Access Compliance Report

Public Rights-of-Way

Intersection ID: 30613	Main Street: GOLF_LINKS_DR	Cross Street: PROVIDENCE_RD	Location: NE
ADA ID: 18CBCC478813	Ramp Type: Perp	Initial Pass/Fail: Fail	Overall Compliance: No
		Severity Score: 12.5

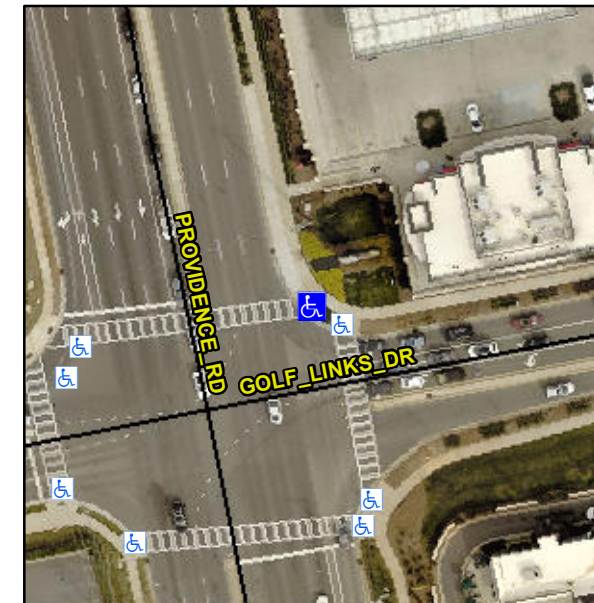
Not Found, R304.5.3

Compliance	Description	Data	Compliance	Description	Data
N/A	Ramp Length (in)	96.0	Yes	Ramp Slope (%)	7.8
Yes	Ramp Width (in)	48.0	No	Ramp XSlope (%)	6.6
N/A	Flare Type LT	N/A	N/A	Flare Type RT	N/A
N/A	Flare Slope LT (%)	N/A	N/A	Flare Slope RT (%)	N/A
N/A	Flare Traversable LT?	N/A	N/A	Flare Traversable RT?	N/A
N/A	Landing Length (in)	N/A	N/A	DWS Provided?	N/A
N/A	Landing Width (in)	N/A	N/A	DWS Contrast?	N/A
N/A	Landing Slope (%)	N/A	N/A	DWS Length (in)	N/A
N/A	Landing X Slope (%)	N/A	N/A	DWS Full Width?	N/A
N/A	Landing Curb? (Y/N)	N/A	N/A	DWS Offset (in)	N/A
N/A	Shared Landing?	N/A			
N/A	Gutter Ponding?	N/A	N/A	Gutter Slope (%)	N/A
N/A	Gutter Lip Ht (in)	N/A	N/A	Gutter X Slope (%)	N/A
N/A	Painted X Walk1?	Yes	N/A	Painted X Walk2?	N/A
	X Walk 1 Direction	To W		X Walk 2 Direction	N/A
N/A	X Walk 1 Width (in)	105.0	N/A	X Walk 2 Width (in)	N/A
	X Walk 1 Slope (%)	2.5		X Walk 2 Slope (%)	N/A
	X Walk 1 X Slope (%)	6.0		X Walk 2 X Slope (%)	N/A

Remove & Replace Entire Ramp.
